Flight Procedures Cover Page	Task Action: FLIGHT CHECK	Task Type: IAP	Estimated Chart Date: 07/11/2024	APWS Task ID: 68C514FFCA7C42E0BAFBC9CD13807700	APWS Project ID: 80F438CDAF414C0BBAC65CF708A46F88
Procedure: RNAV (RNP) Z RWY 35R AMDT 1		Enroute: NO	Specialist: Brandenburg, Phillip		Agreement Number:
Airport ID: KSDF			Airport City: LOUISVILLE		State: KY
Facility ID:	Facility Type:	Flight Inspection Remark Type: New FC Slot			
<div>Procedure Comments: ACTIVE DATA USED FOR KSDF</div> <div>APPROVAL LETTER (1) - MANDATORY ALTITUDES AT INTERMEDIATE FIXES MLLEY, TUSCR</div> <div>CONTACT ALLAN WILL 4059546103</div> <div>QUALITY 20 CHECKED</div> <div>QUALITY 38 CHECKED</div>

Date: November 14, 2023
To: Tom Lattimer, FAA CSA OSG PBN Co-Lead
From: Jeffrey Chester, TCID Airspace and Procedures Manager
Prepared by: Scott Enander, Senior ATC Specialist, NAVTAC Support
Subject: Letter of Approval Request KSDF RNAV (RNP) Z RWY 35R

KSDF RNAV RNP Z RWY 35R: MLLEY and TUSCR Mandatory Altitude.

RNAV (RNP) Z RWY 35R
LOUISVILLE MUHAMMAD ALI INTL (SDF)

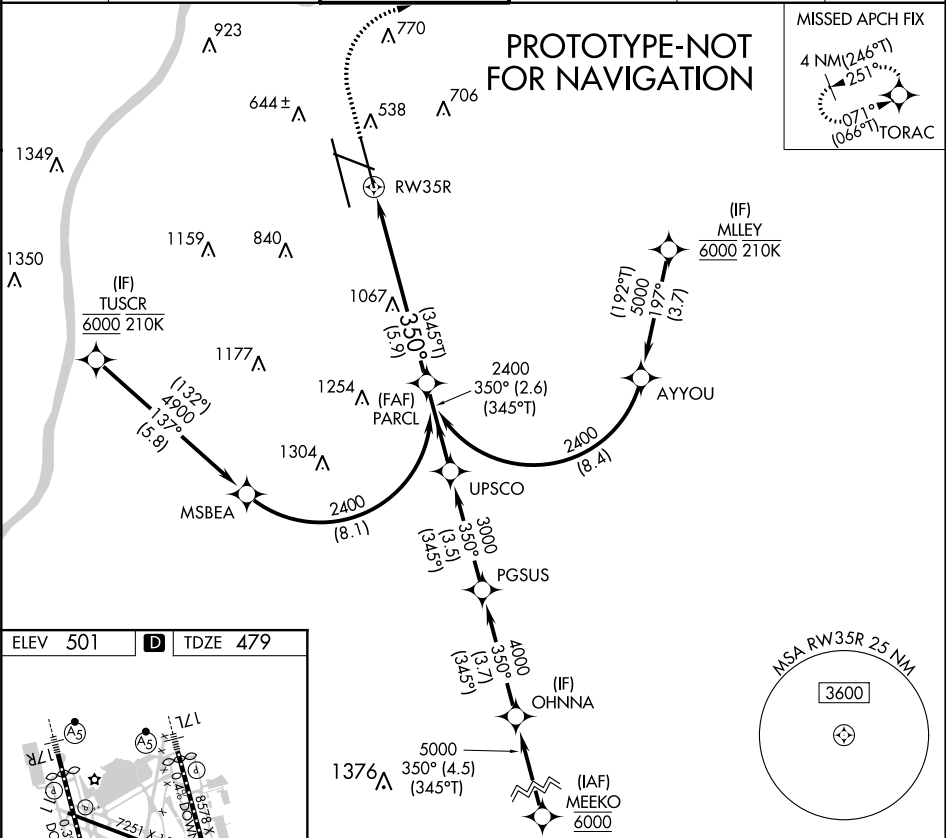
KSDF TRACON requests AFS approval to chart mandatory altitude restrictions at the following fixes; MLLEY and TUSCR at 6000ft MSL for RNAV RNP Z RWY 35R instrument approach procedure for Louisville Muhammad Ali International Airport (KSDF).

Currently, FAAO 8260.19I paragraph 8-6-10n (1) requires Flight Standards approval from the Flight Technologies and Procedures Division to chart a mandatory altitude on the intermediate segment of an instrument approach procedure.

Therefore, Louisville TRACON requests to chart mandatory restrictions at MLLEY and TUSCR RNAV RNP Z RWY 35R. This is an ATC operational request to ensure vertical separation between aircraft on the approach and other TRACON traffic.
